Re: Planning Commission Recommendation for Toll PA XVIII, L.P.  
Conditional Use Application II for Flexible Development of Crebilly Farm

Re: Conditional Use – The Robinson Tract  
# Westtown Township - CU-09-19-16071

Figure 2: Site Plan Detail, Sheet 12, Conditional Use Application, The Robinson Tract

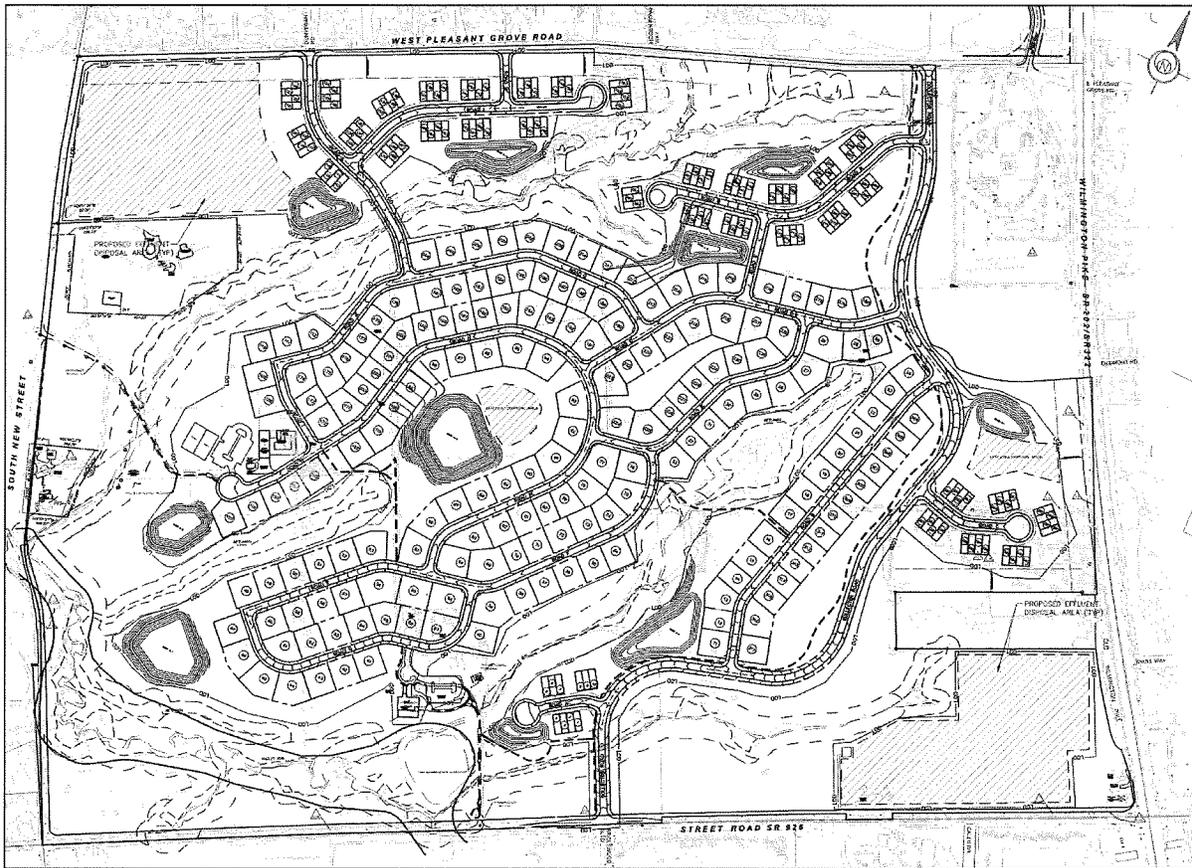
24. While Sheet 12-Overall Lot Layout provides a brief list of the tract area, proposed density and proposed impervious coverage of the development, it does not provide a zoning compliance table. This should be clarified by the applicant.

Figure 3: Brandywine Battlefield Swath, Approximate troop movements and battlefield skirmishes

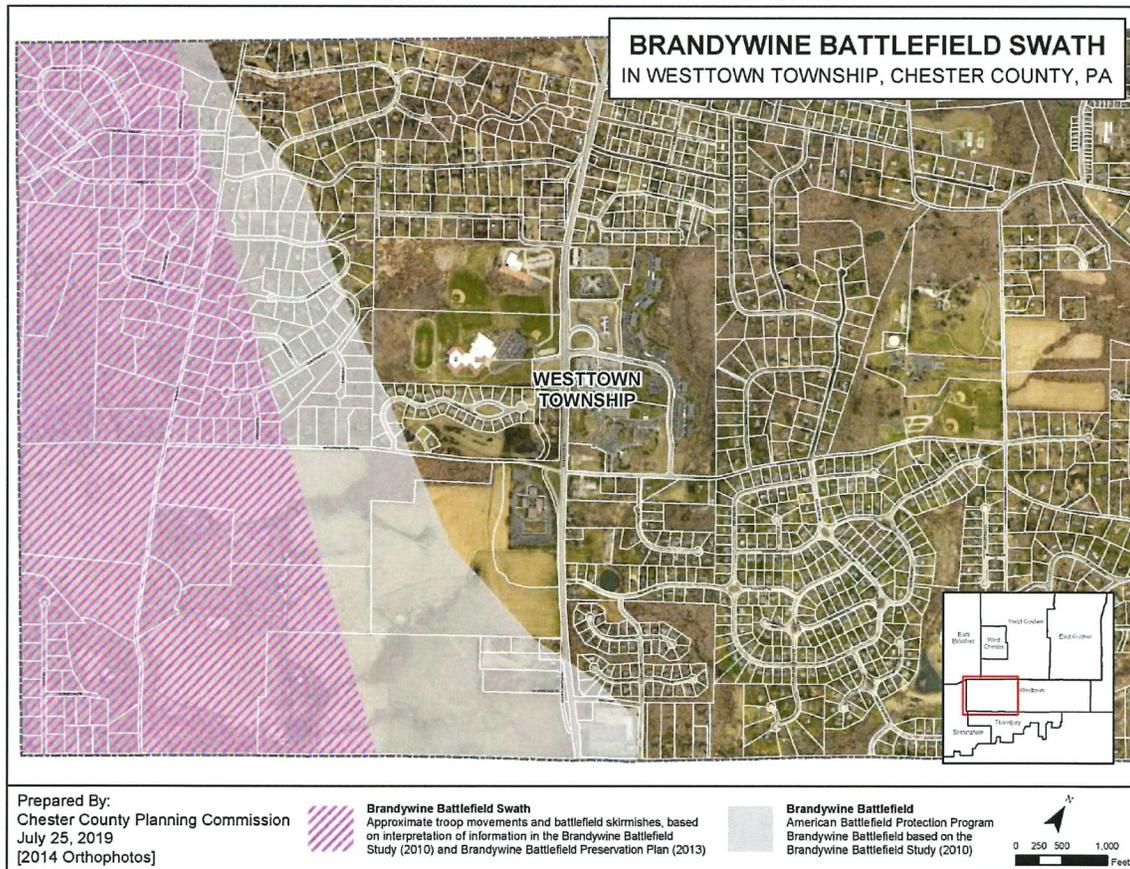
- 22) Prior to issuance of grading permits, Applicant shall cause to be conducted an archeological survey including ground penetrating radar survey of any areas proposed to be disturbed within the Brandywine Battlefield Swath which is depicted on the CCPC review letter dated October 18, 2019, Figure 3. Applicant shall share the

Figure 4: Chester County Planning Commission's conceptual illustration of development on the Robinson Tract (December 7, 2016)

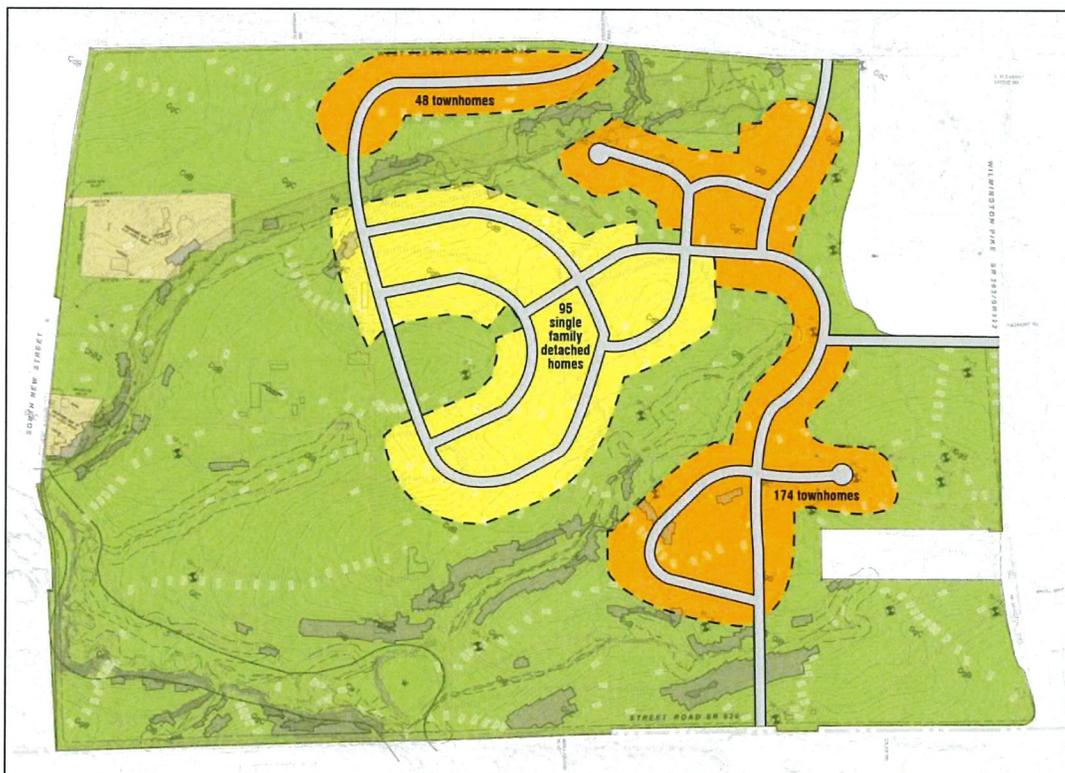
5. The County Planning Commission recommends that the applicant and Township consider the development of a revised site plan in which the proposed development activity is located, to the greatest extent possible, on the eastern portion of the site outside of the **Rural Landscape** designation, and outside of the Brandywine Battlefield, particularly the area of approximate troop movements and battlefield skirmishes shown in Figure 3 on page 4 as the “Brandywine Battlefield Swath.” This will also provide some protection for the Crebilly Farm which is eligible for the National Register as a gentleman’s farm. Additionally, we note that the Westtown Inn (aka Darlington Corners Inn, built circa 1820) at the northwest corner of the Route 202 and Route 926 is eligible for the National Register of Historic Places. “Appreciate” Objective A of *Landscapes3*, the 2018 County Comprehensive Plan, is to preserve historic resources in their context while supporting appropriate reuse as a vital part of our community infrastructure and character. Additional information on this issue is available online at: [www.chescoplanning.org/Landscapes3/1c-Appreciate.cfm](http://www.chescoplanning.org/Landscapes3/1c-Appreciate.cfm).

Figure 4, which was also provided in our previous review letter, provides a conceptual illustration of how development activity on the Robinson Tract can be located outside of the majority of the Rural Landscape and Brandywine Battlefield area. The County Planning Commission would be happy to work with the applicant and the Township on alternative sketch plans of the site that have a higher proportion of townhouses, along with more open space provided on the portion of the tract located in the Rural Landscape.

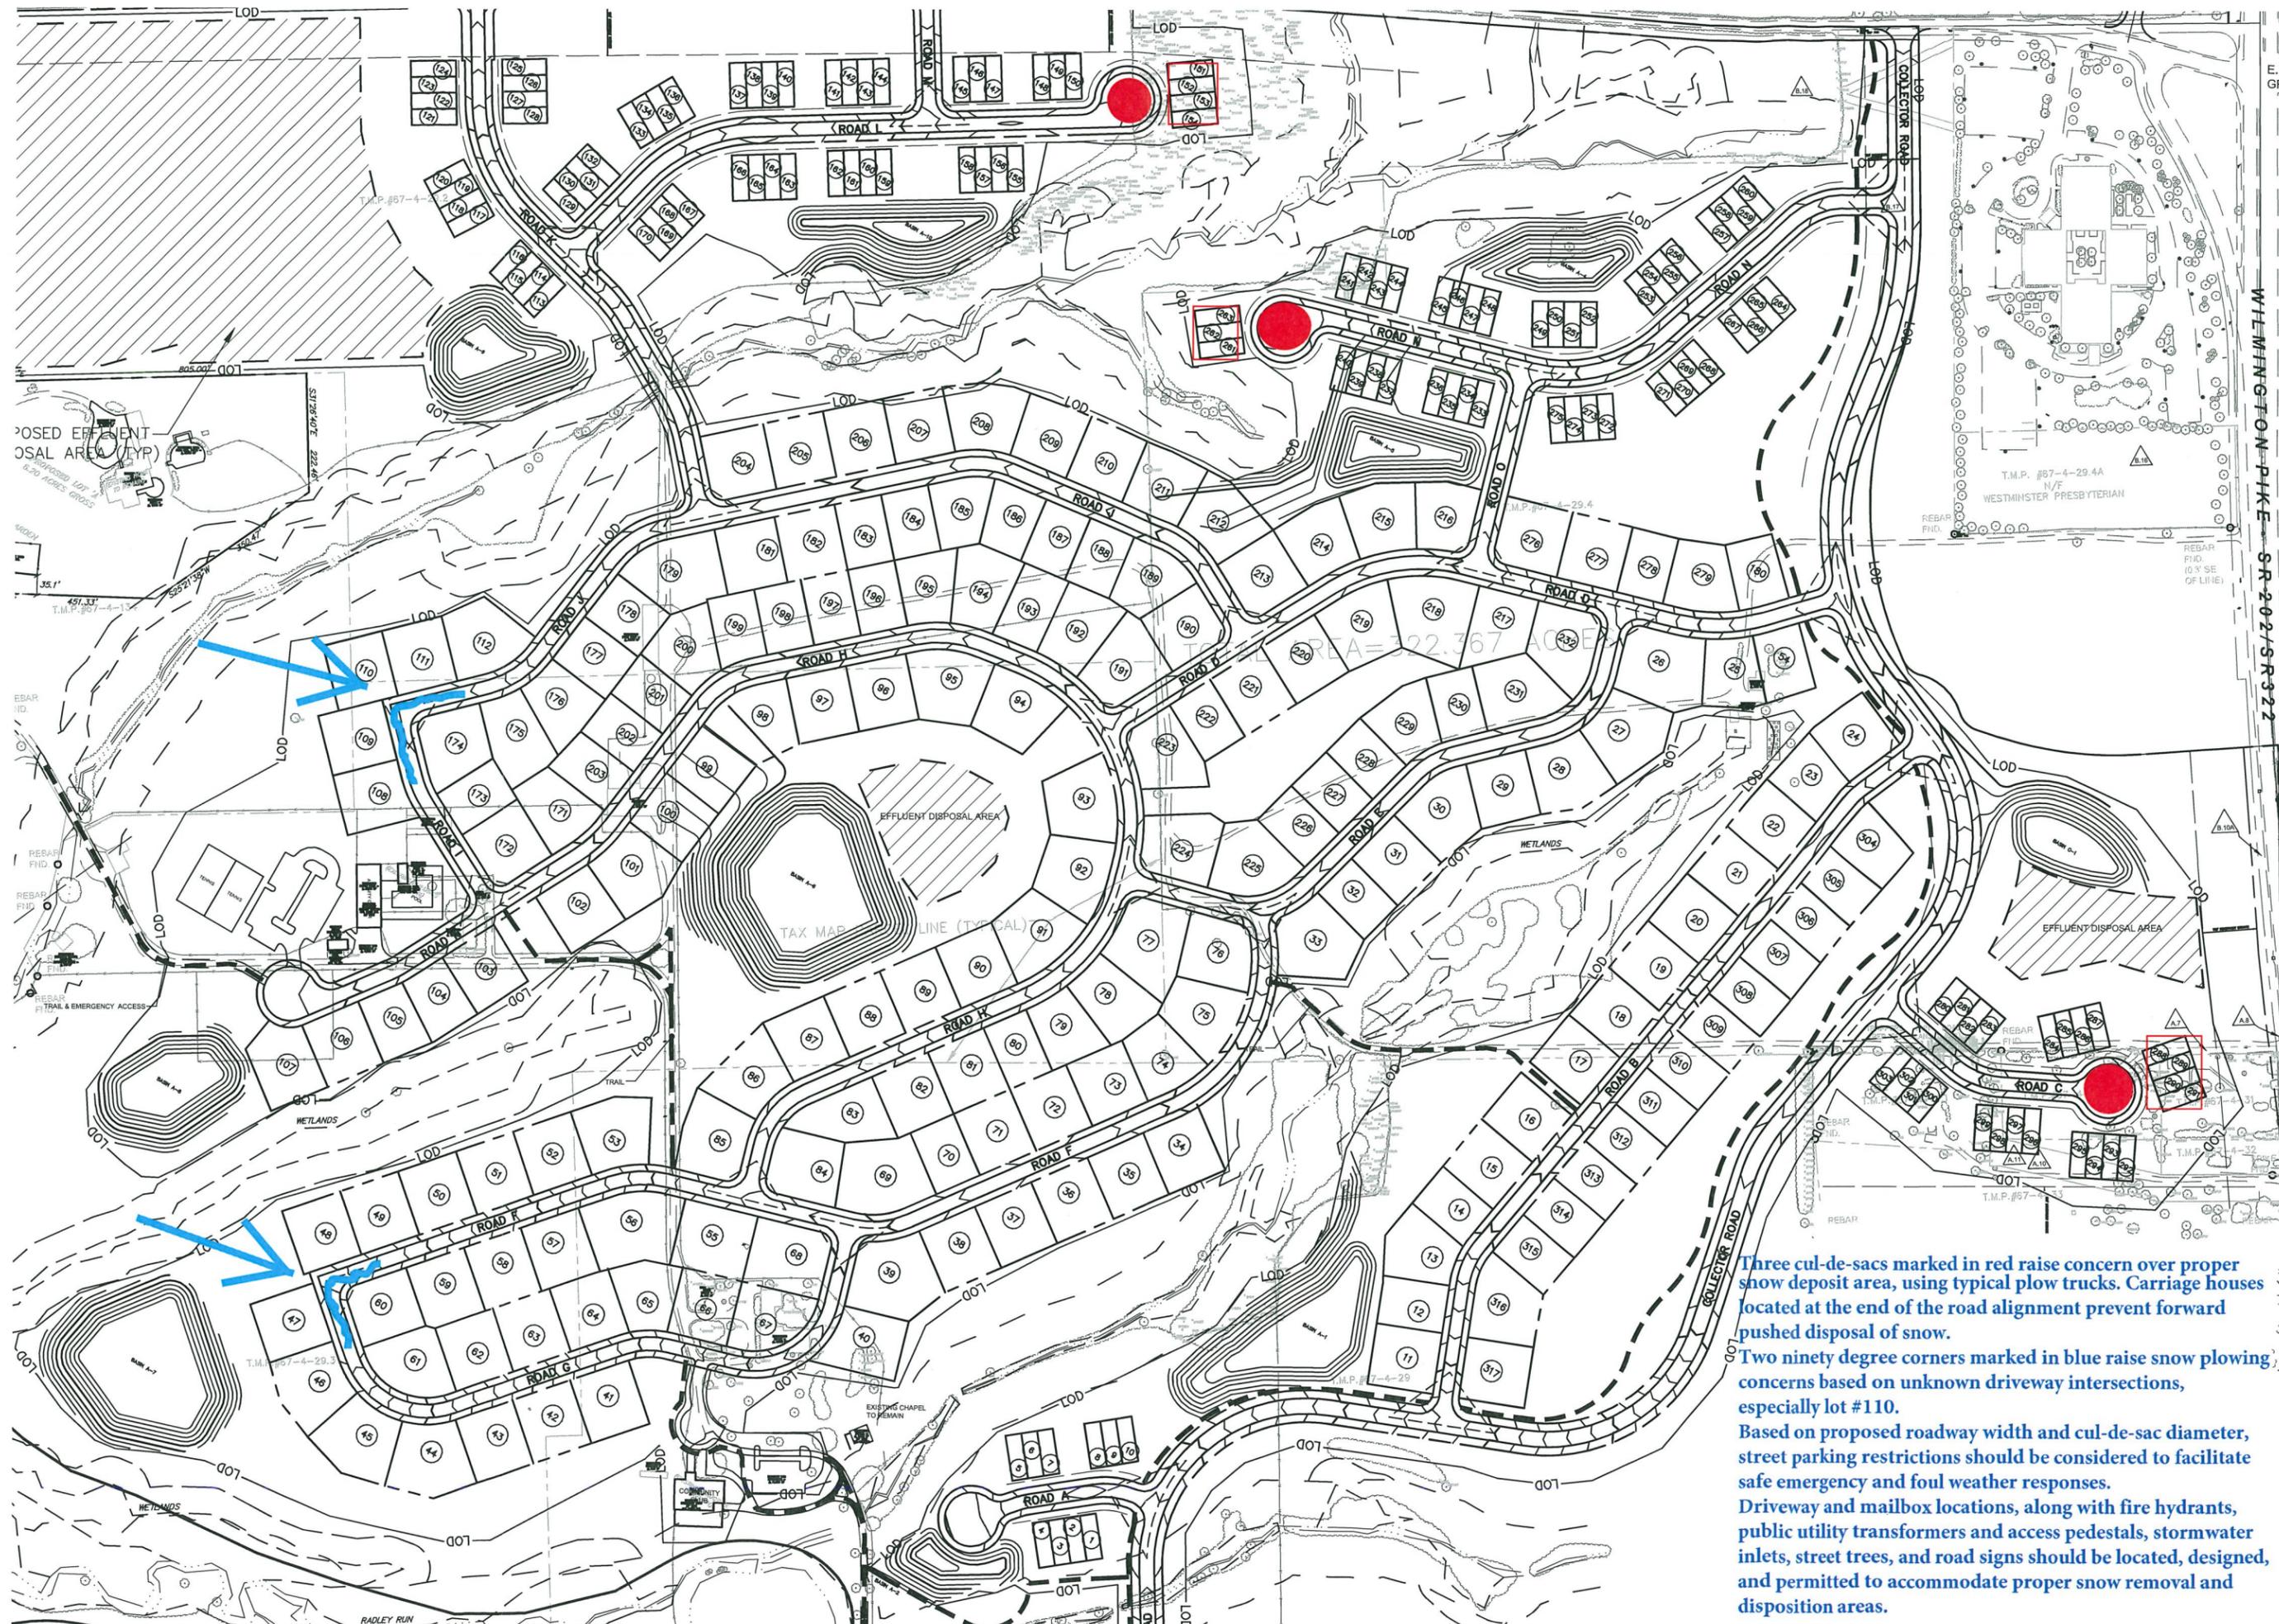
Three cul-de-sacs marked in red raise concern over proper snow deposit area, using typical plow trucks. Carriage houses located at the end of the road alignment prevent forward pushed disposal of snow.

Two ninety degree corners marked in blue raise snow plowing concerns based on unknown driveway intersections, especially lot #110.

Based on proposed roadway width and cul-de-sac diameter, street parking restrictions should be considered to facilitate safe emergency and foul weather responses.

Driveway and mailbox locations, along with fire hydrants, public utility transformers and access pedestals, stormwater inlets, street trees, and road signs should be located, designed, and permitted to accommodate proper snow removal and disposition areas.

- 49) Applicant shall revise the Plan to relocate the proposed carriage homes at the end of the cul-de-sacs which are highlighted in red on the attached map which was prepared by the Township's Public Works Director. The Plan shall provide open areas off of the cartway of the cul-de-sacs to allow for the deposit of snow that is shoveled from the road.

- 50) Applicant shall revise the Plan to redesign the 90° bends in Road J and Road F which are highlighted in blue on the attached plan to eliminate difficult maneuvers by snowplow vehicles.

- 51) The Plan shall be revised to add notes that restrict parking on certain roads if necessary to facilitate access by emergency vehicles and snow plows.

- 52) Driveway and mailbox locations, fire hydrants, public utility transformers, access panels, stormwater inlets, street trees and road signs should be designed and located in areas which allow for proper snow removal and snow disposal areas.
